Countries: CANADA, UNITED STATES, MEXICO **Document ID:** IK0700051
Availability: ISIS, FleetISIS **Revision:** 3
Major System: EXHAUST **Created:** 12/20/2012
Current Language: English **Last Modified:** 1/10/2013
Other Languages: NONE **Author:** Charles Sun
Viewed: 850

Title: Rear Exhaust Manifold Leak

Applies To: MaxxForce® DT, 9 and 10 (2010 M.Y.)

Photo Showing the Revised Manifold

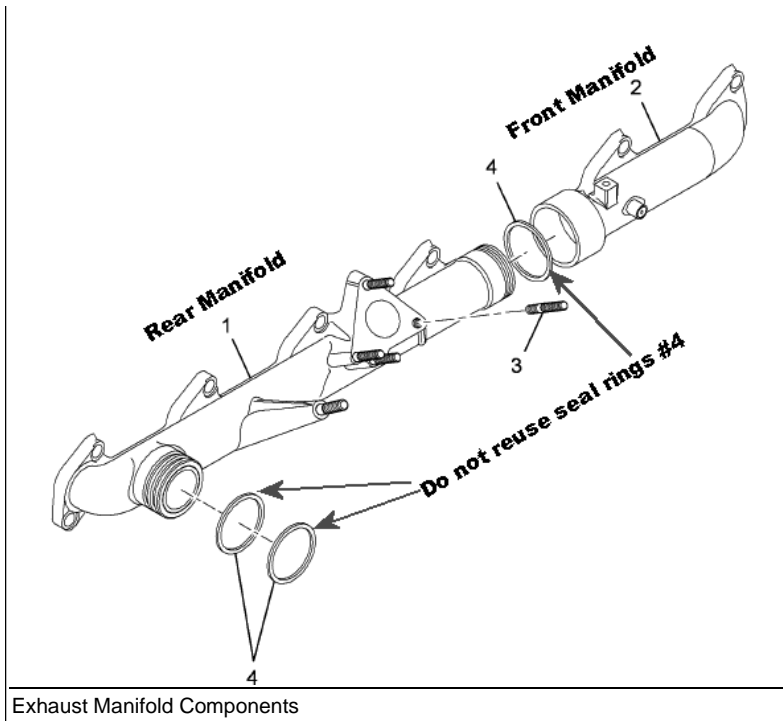
When truck is serviced for rear exhaust manifold leak, check for presence of a square shaped ear at rear of exhaust manifold. Current production exhaust manifolds have been modified to remove ear and existing inventories had these ears machined off.
